Addendum No. C

To the contract documents for NORTH VERDEMONT ELEMENTARY SCHOOL, DSA No. 04-122168

For the SAN BERNARDINO CITY SCHOOL DISTRICT

LPA Project No.: 30899

L5.02

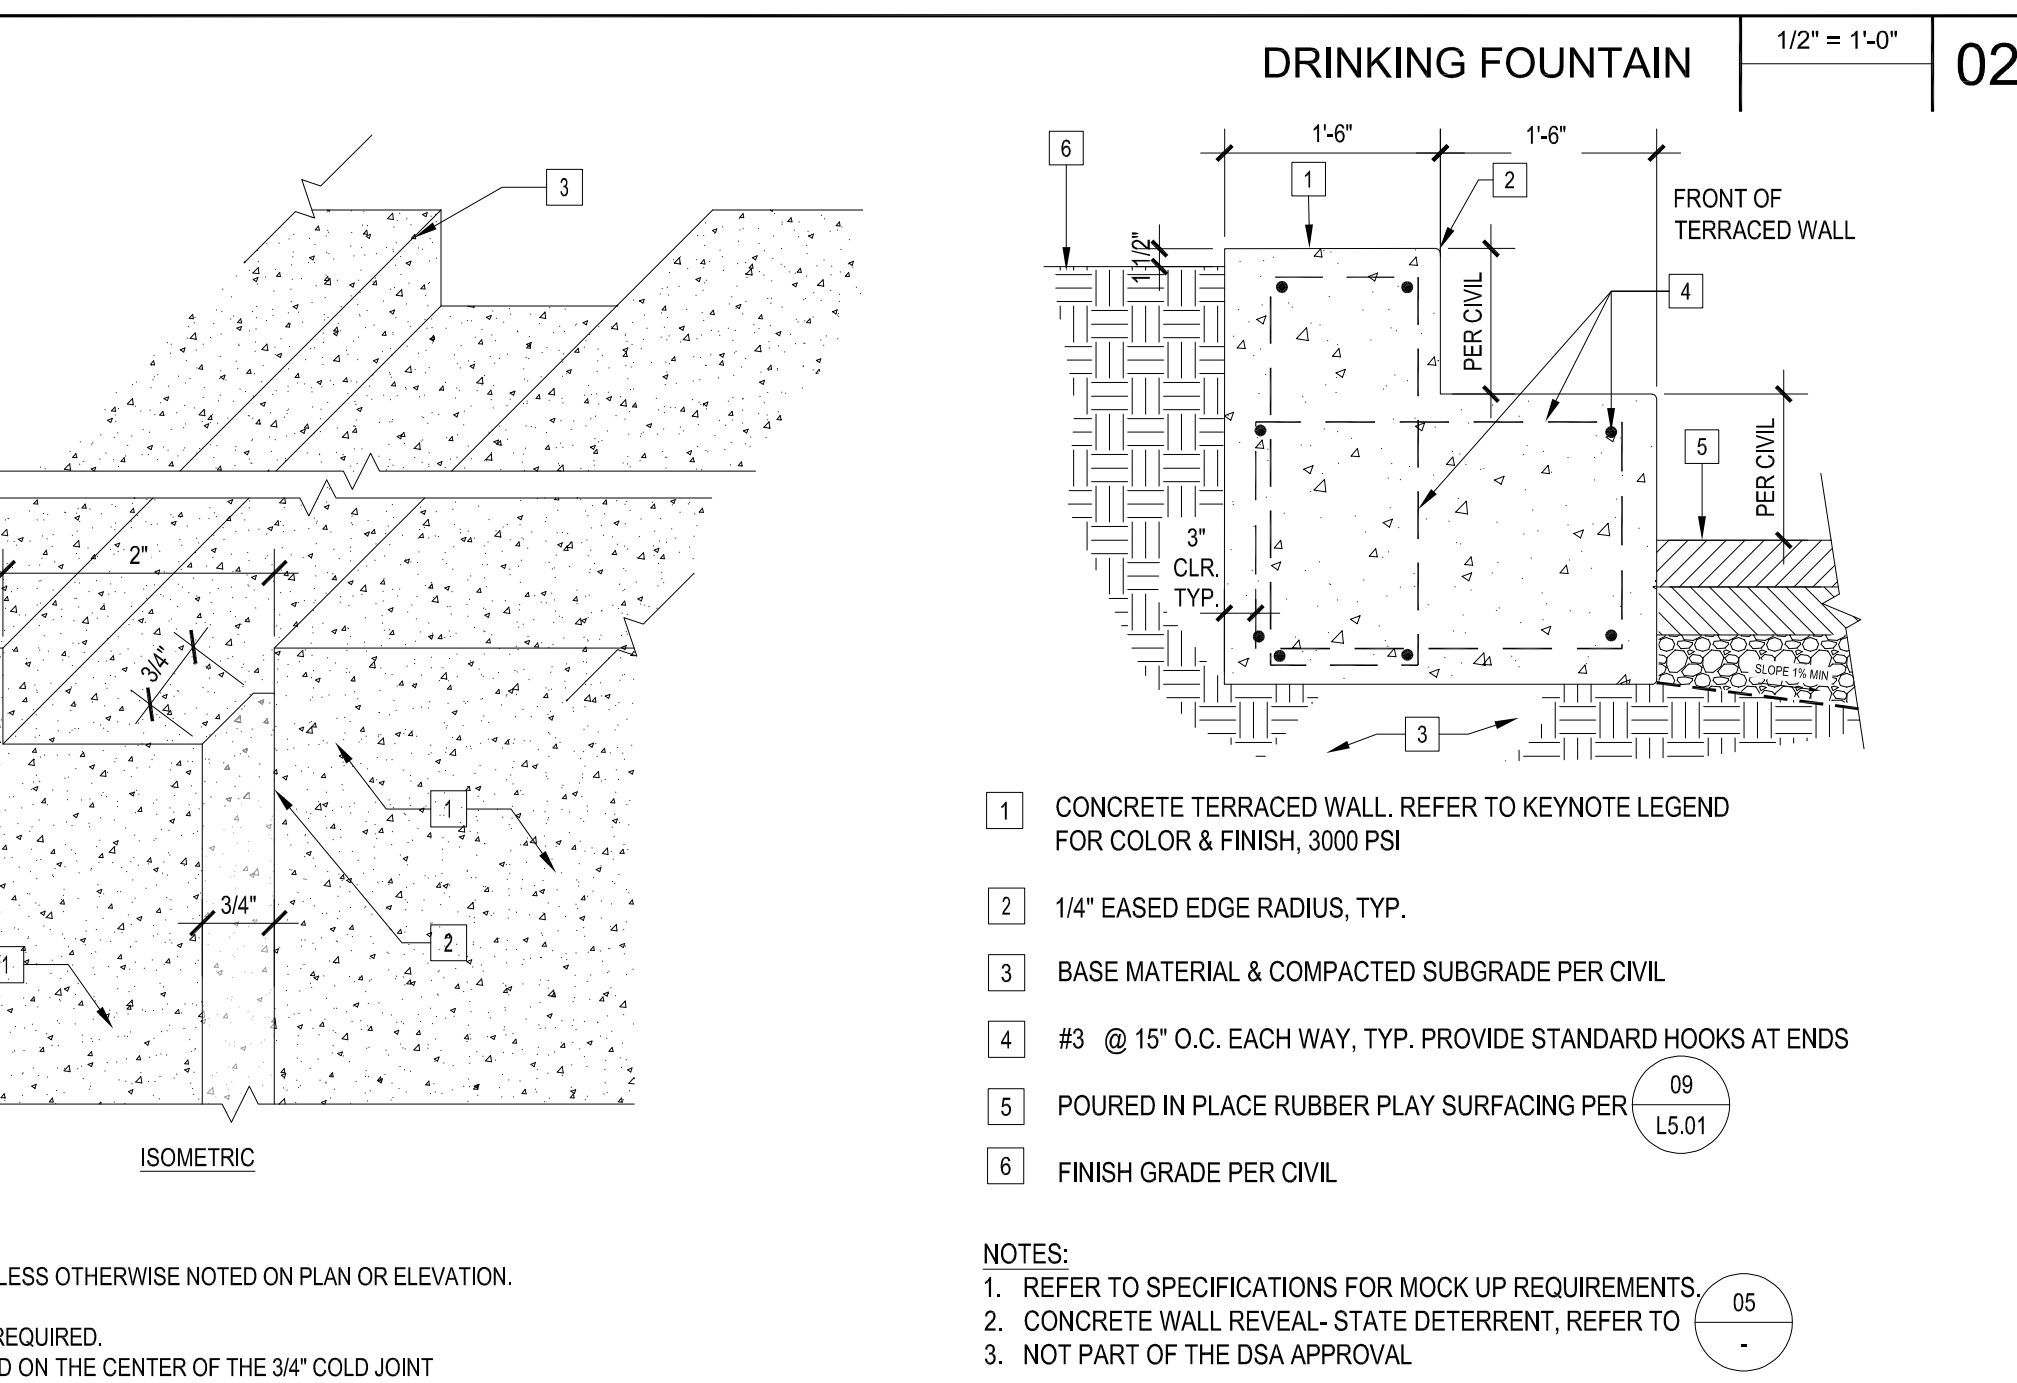
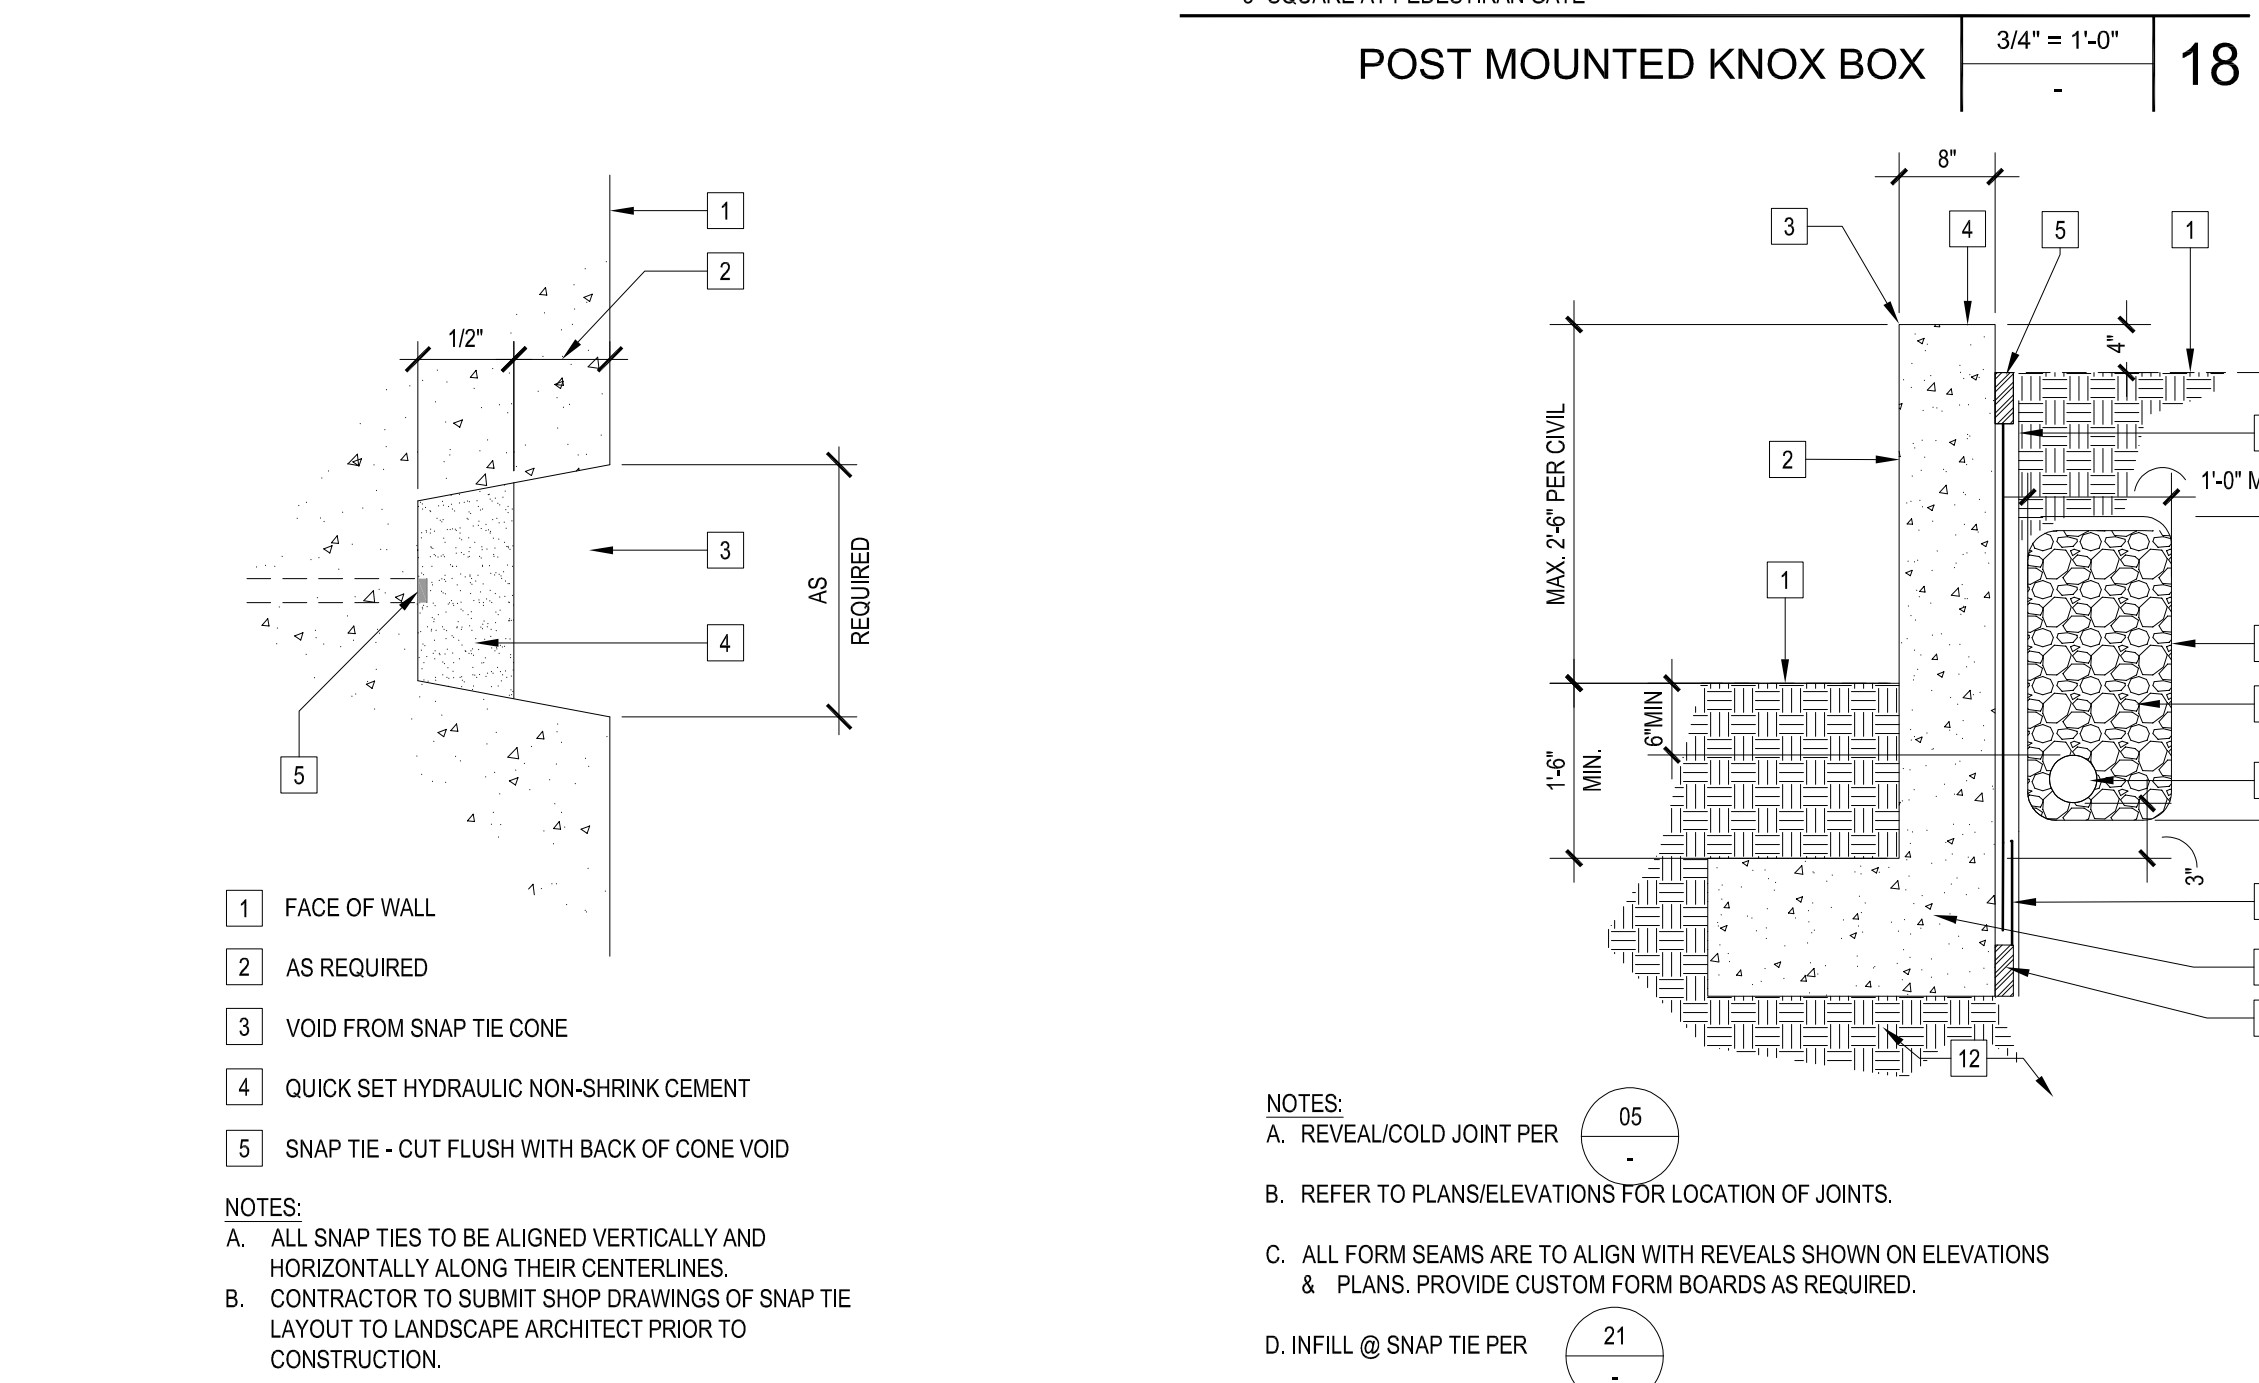
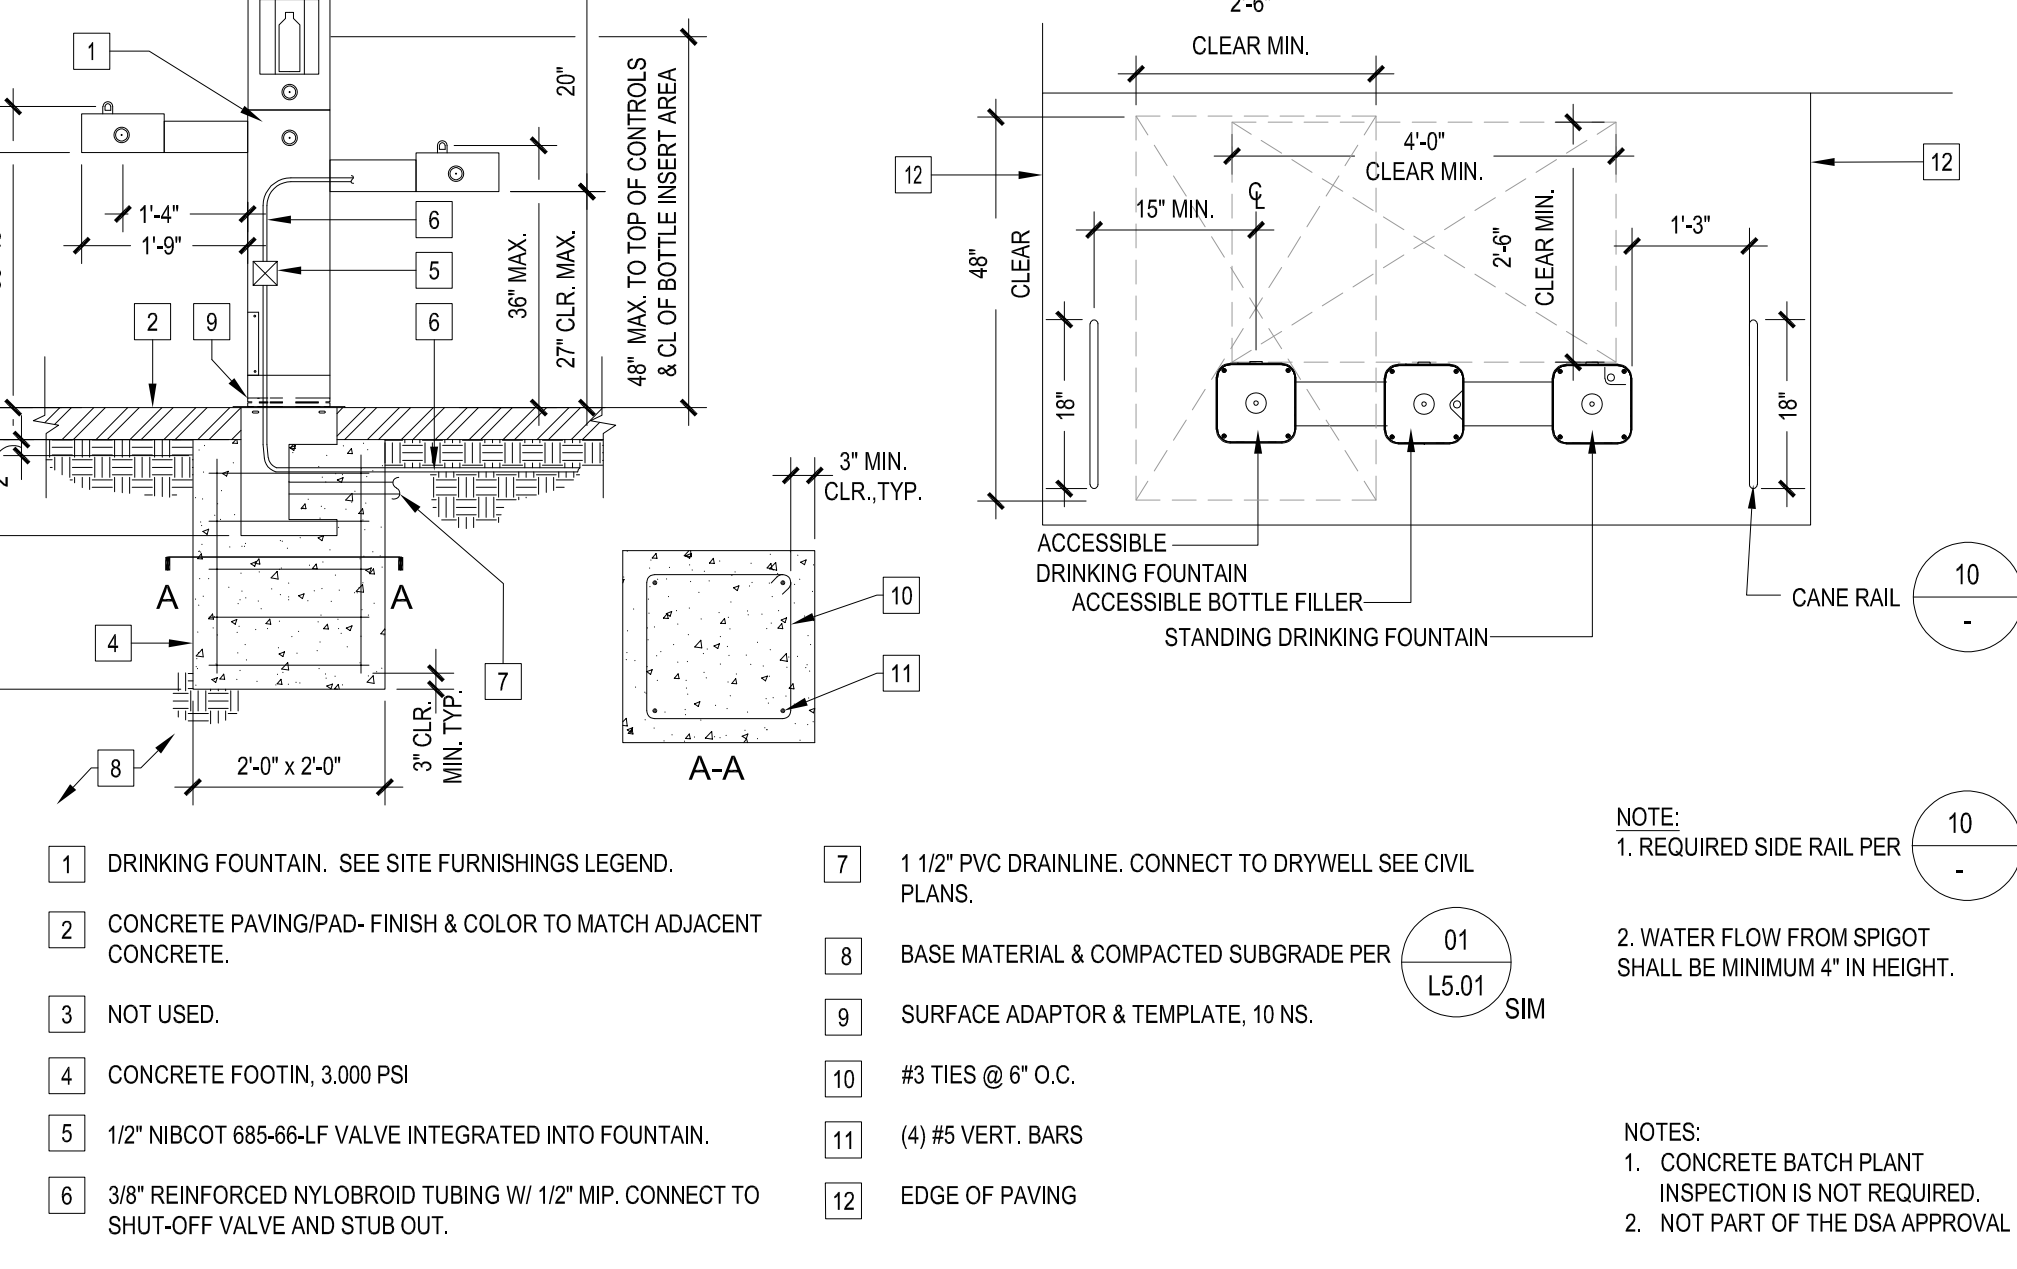
- Item No. 16**      L5.01 – Construction Details
  - a) Revised depth of DG.
- Item No. 17**      L5.02 – Construction Details
  - a) Added bike rack detail.

- b) Revised Metal Picket Swing Gate detail.
  - c) Revised notes on details.
- Item No. 18**      L5.03 – Construction Details
  - a) Added CMU Retaining Wall detail.
